**Morecambe Offshore Windfarm Generation Assets Development Consent Order
Application Planning Inspectorate Reference: EN010121**

Decommissioning Minutes

Morecambe Net Zero (MNZ) Minutes

Annex 1 – Slide shared by CR

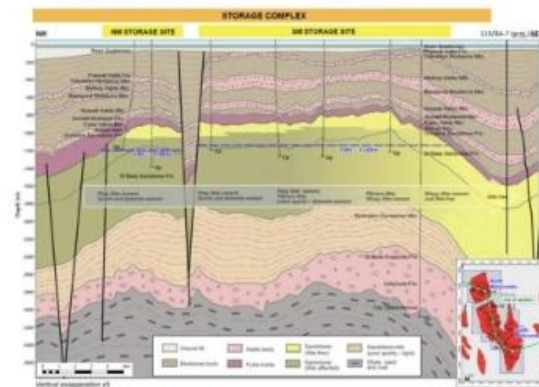
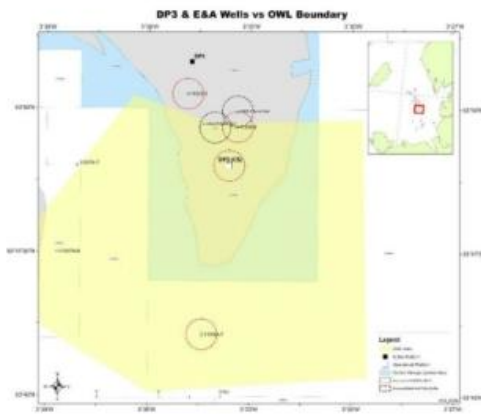
CR	So perhaps the question I had still stands. There is a potential need to drill beneath wells or over existing legacy wells [<i>CR shared the slide at Annex 1</i>]. With reference to C5 and 110/8-2, the one next to South Morecambe – there is a leakage risk and it is outside licence area. What is Spirit's view on the criticality of that well?
AS	So why would you consider 8A-7 to be an issue? We have been given a location and it should have been plugged and abandoned already. Secondly, with the two wells you think you need access to in order to do a relief well, considering they have also been plugged and abandoned.
PM	All of the wells on the map are part of our well integrity assessment, which is part of our carbon storage licence commitment. This is ongoing at the moment. We have to submit a well integrity report and evaluation before well characterisation. The NSTA – after early risk assessment – defined which wells they wanted us to investigate. They said any well in hydraulic communication with our future storage site. So not just wells in the gas field, but also offset wells to the south, including 8A-7, which is outside the licence area but penetrates the same reservoir area.

- C5 and 110/8-2 – can relief well (if needed) be undertaken prior to MOWL construction?
- 110/8A-7 – lies to the South of existing gas field and is outside carbon storage licence area. MOWL considers this negligible risk of leakage and will not need intervention – does Spirit agree?

AS	Is that part of the aquifer that is completed? There is limited ingress so virgin pressure.
PM	There is an active aquifer on South Morecambe. We experienced aquifer ingress through production lifetime. The DP3 location on that map experienced water through wells. The DP4 platform to the north did too. The aquifer was active on the eastern flank of the gas field and also proven through wells drilled off structure. There is another gas field called the Bains field about 6-7 km from South Morecambe and that is in pressure communication with Morecambe. We have monitoring information that demonstrates that. The 8A-7 well was drilled and it had some depletion and there is a well further north-east which had evidence of pressure communication through the aquifer. Essentially, the NSTA used that to define which wells should be in the integrity assessment. Seven of them are off structure and a long way from the actual future storage site. That is why this well is currently in our assessment and we are flagging it. The way the process will work through the CS licence over the next 18 months is that we will complete the well integrity assessment, then integrate the outcome from that into the containment risk assessment, that will then drive the monitoring plan, then the monitoring plan will drive what the corrective measures plan needs to be in place. So following through: if you have a well that is in the containment risk assessment and the outcome is that we need to monitor that well, then we need a

corrective measures plan in place for that well. Ultimately monitoring and corrective plans need to be agreed with the regulator before the permit application.
AS	I appreciate there is ongoing work, but for the 8A-7 well, that looks low risk that any CO2 will make it down that well?
PM	I wouldn't disagree with the way you have assessed it, it's not high risk for us. As we follow through the process with the regulator, they recognise that it has been abandoned to OEUK guidelines so don't anticipate work prior to carbon storage. It's a case of whether it requires monitoring.
AS	Do you know of any mechanism for how CO2 will make it to that well from the injection site? There are no known geological pathways.
PM	As per your report, it's a low likelihood that CO2 will migrate that direction. This would mean there are no catastrophic containment issues. It's the fact there is hydraulic communication which needs to be included – we've seen it in the production lifetime, so would in the storage lifetime.

and intervene if you see leakage from that well. So we have to set out a monitoring plan, and worst case scenario is we have to re-abandon that well.
CR	For C5 in the north and 8A-7 in the south, do you foresee that you can work that over from outside the windfarm area by some means?
PM	At the moment, we don't think we could do remedial work at C5 or 8A-7 without a rig on location. For the well in north, we can potentially reach it from outside windfarm location – we can deviate by a new well to intersect and do remedial work. But that wouldn't be possible at 8A-7.
RH	Just an observation from me, but this granular detail is extremely helpful for getting protective provisions that are mutually agreeable. Everything that is being said opens up how to capture this sort of co-existence. My question is on the granular detail: in terms of access for monitoring for future re-abandonment in the worst case scenario, what is the requirement for that?
